Phoenix Theatre, 112 Charing Cross Road, London, WC2H 0JP

Delegated Report (Members Briefing)		Analysis sheet		Expiry Date:	22/03/2023
		N/A / attached		Consultation Expiry Date:	02/04/2023 (original site notice) 22/06/2023 (updated site notice)
Officer			Application Number(s)		
Elaine Quigley			(i) 2022/5537/P (ii) 2023/0874/L		
Application Address			Drawing Numbers		
Phoenix Theatre 112 Charing Cross Road London WC2H 0JP			See draft decision notices		
PO 3/4	Area Team Signature	C&UD	Authorised Officer Signature		
Proposal(s)					
<p>(i) Change of use of existing commercial units on Charing Cross Road from Class E(a) to ancillary theatre use (sui generis) to provide flexible area for uses including bar, lounge, ticketing and merchandising and associated alterations to shopfronts, infill extension within the rear lightwell to provide a passenger lift with installation of mechanical plant and associated screening at first and second floor levels, additional roof top plant and alterations to the ground floor fenestration including replacement canopy to Charing Cross Road</p> <p>(ii) External and internal works including installation of roof top plant, new opening to rear auditorium

Figure 6 (above): Existing and proposed ground floor plan

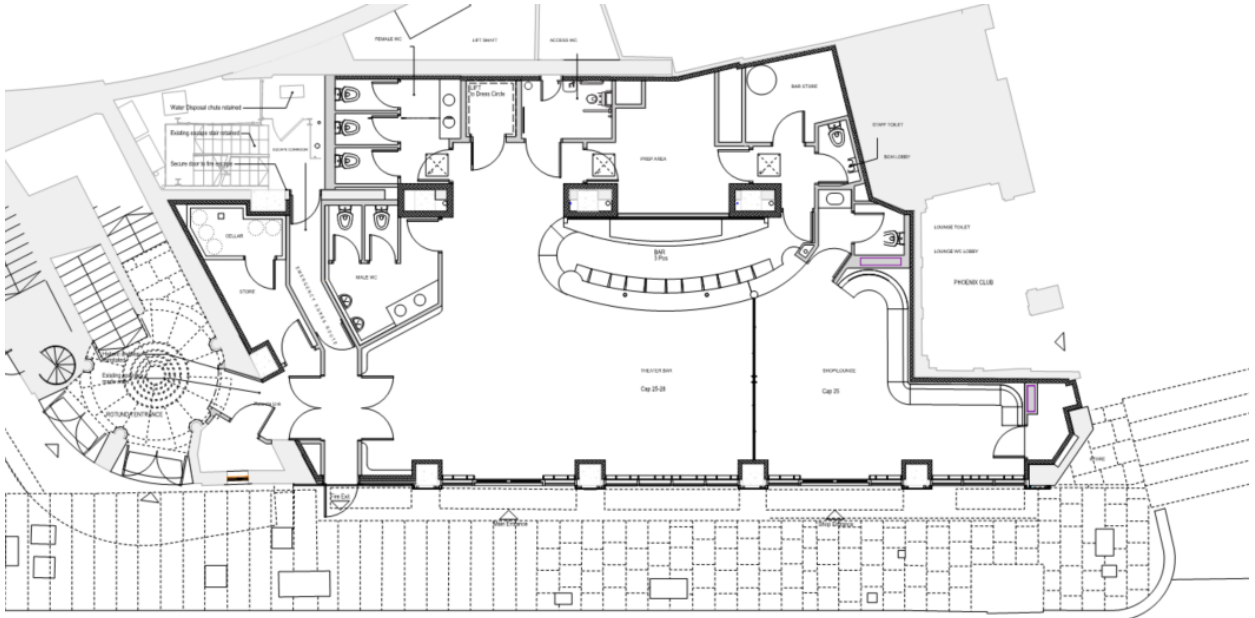
6.3 Traditionally it seems there have always been shopfronts on the Charing Cross Road frontage (albeit not listed, although the building is considered to make a positive contribution to the conservation area). The proposals involve the removal of the existing shopfronts, which are non-original and out-of-keeping. A series of windows incorporating entrance doors to the bar and retail space would be proposed as replacements. The proposed shopfront designs follow the original Art Deco style of the upper floor windows. The original design of the shopfronts included full-height glazed openings and transoms. This resulted in the shopfront glazing being out-of-scale, both with the host building and with the adjacent theatre entrance creating an industrial appearance that was considered to be out-of-keeping with the character and appearance of the conservation area. This element of the scheme has been revised to remove the transoms and the width of the windows reduced in height to match the top of the door openings on the Rotunda entrance to the theatre. The proposed changes would improve the overall scale of the shopfronts and would be considered acceptable subject to a condition requiring further details to be provided. The proposal originally included the installation of powder-coated metal backed sheeting along the pilasters on the Phoenix Street and Charing Cross Road ground floor elevations. This was considered by the applicant as a recognisable shopfront material, durable and could be easily replaced when damaged. The applicant was encouraged to revisit this as it was not considered an appropriate material for a historic building. Following further discussions, a ceramic panel has been proposed which can be textured and coloured in a multitude of ways. The proposed finishes would be considered a more appropriate material for the pilasters between the shopfronts. Further details of finishes and manufacturers specifications would be secured by condition.

a) Plan, elevation and section drawings at scale 1:10, showing the new shopfront frames, mullions, details of the pilaster finishes and details of how these would be set into the existing openings.

Figure 8 (above): Existing and proposed upper circle (Second floor) plan

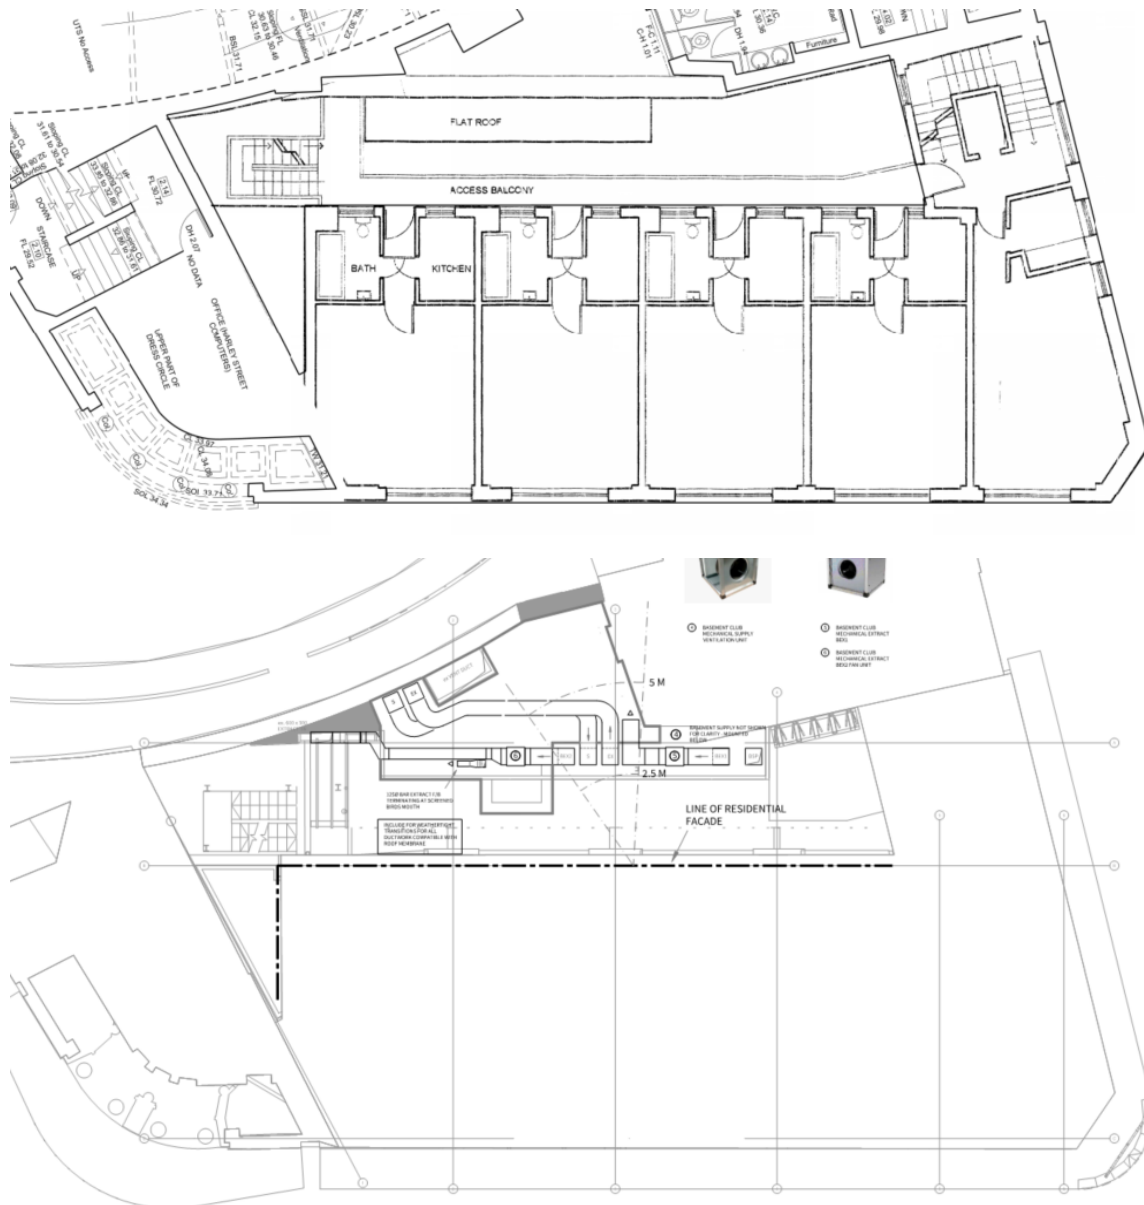
6.5 The proposal would include an extension behind the auditorium at upper circle level which occupies a position above an existing plant area within the lightwell between the theatre and the Charing Cross Road housing block. The extension would accommodate a lift from ground-floor level to the dress circle of the auditorium with a lobby to store wheelchairs during performances, giving level access to the dress circle. It would be topped by a flat roof which would be home to air conditioning units.

6.6 The extension would be an addition to the envelope of the main theatre auditorium which generally retains its original form. It would appear the theatre has not been extended in its 90 year existence, other than at roof level for various plant and other accretions. The extension would be back-of-house within the lightwell, so not visible from the street. The extension would be separated from the access decks in an area which already is somewhat unsightly.

6.7 The proposed extension would not be visible from the street so would not affect the appearance of the listed building as seen from Charing Cross Road and surrounding streets. As such, it would be a subservient addition to the listed building in an area of secondary importance on the site, which would be in keeping with the rear wall of the auditorium in terms of its height, bulk, form, footprint, scale and materiality.

Figure 10 (above): Existing and proposed southern side elevation (from Phoenix Street)

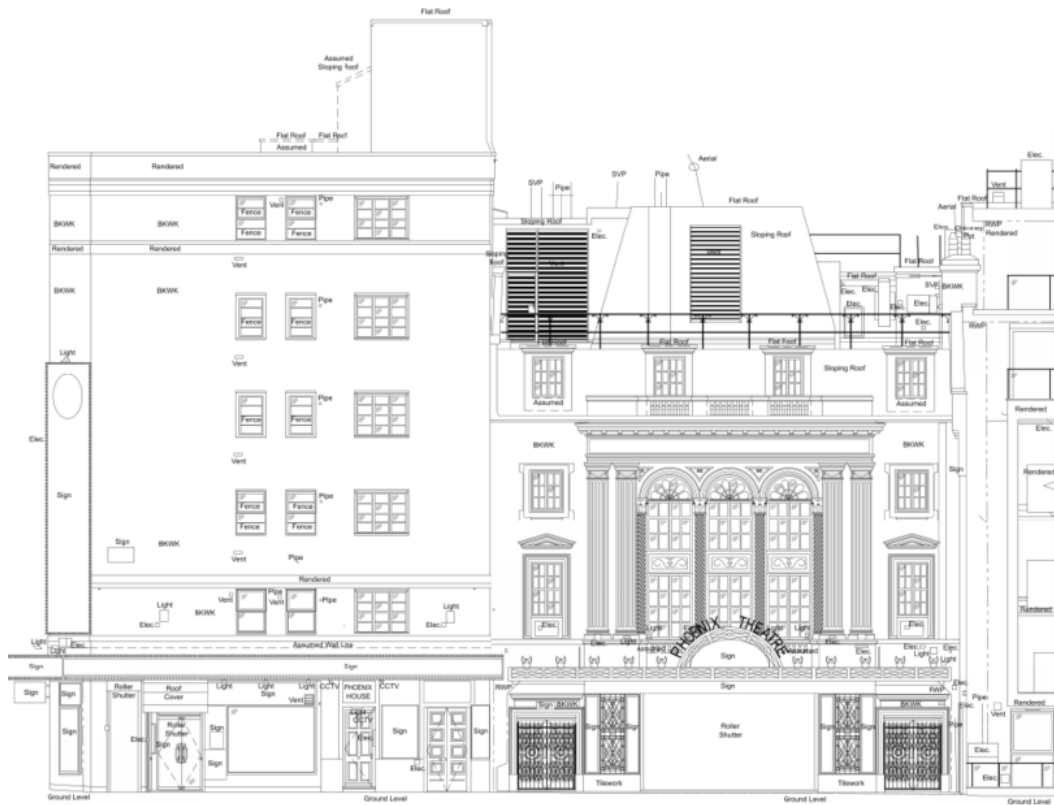
6.8 The proposed works also include renewing the existing theatre canopy and signage which stretch along the Charing Cross Road frontage and into Phoenix Street on the south side. No objections would be raised to the principle of removing and replacing the existing canopy which is non-original (the proposals do not include the recently-renewed curved canopy over the principal theatre entrance). Any replacement and new signage as well as lighting of the canopy and signage would require advertisement consent and would not form part of this permission. It must be noted that a advert application has been submitted to the Council and is pending consideration (see planning history section above for further details).

Figure 11 (above): Existing and proposed rear elevation of Phoenix House

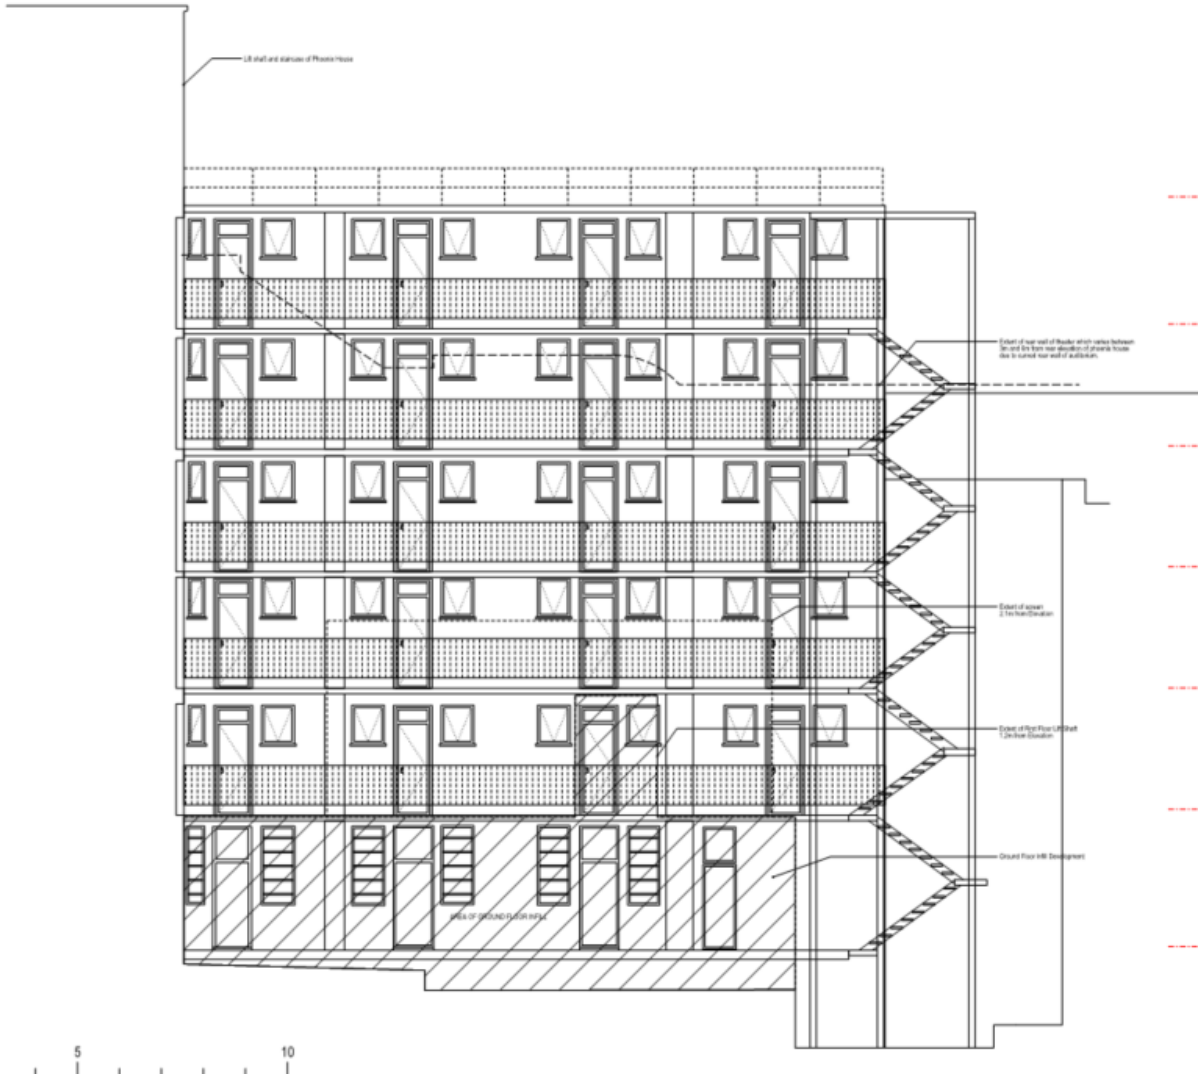
- The partially infill void at the rear of Phoenix House is externally an area of low significance in design and heritage terms because it is not visible from public areas and would not obscure any important historic character or features to the theatre.

7.1 Daylight and sunlight to small high level windows along access balconies to Phoenix House flats have been examined as being the only windows to adjoining residential premises that would be affected by the proposal. The windows serve kitchens and bathrooms. The proposal would include the demolition of the existing ground floor toilet and disused water tanks at first floor level within the lightwell and erection of an infill extension at ground and first floor level to provide the new platform lift enclosure. This extension would be located at the back of the access deck that provides access to the upper floor flats. It would extend 2m in length and would be located in front of a high level window that serves a bathroom and the front door of one of the first floor flats. It would not be considered to have a harmful impact on daylight or outlook to the flats within the upper floors of Phoenix House. The new mechanical plant and associated screen at first and second floor levels would be located on the flat roof of the existing extension within the lightwell to the rear of Phoenix House. The plant and associated screen would be approximately 2.5m from the windows of these flats. It is acknowledged that the separation distance is modest however given the fact that the affected windows serve non-habitable rooms, the impact to the daylight to and outlook from and 3 of the flats on the first floors to and from these non-habitable rooms would be considered acceptable. The louvre screen in front of the mechanical plant is not required for acoustic purposes therefore the details of the materials and finishes are still being explored. A condition would be attached requiring the details to be submitted prior to the relevant part of the works.
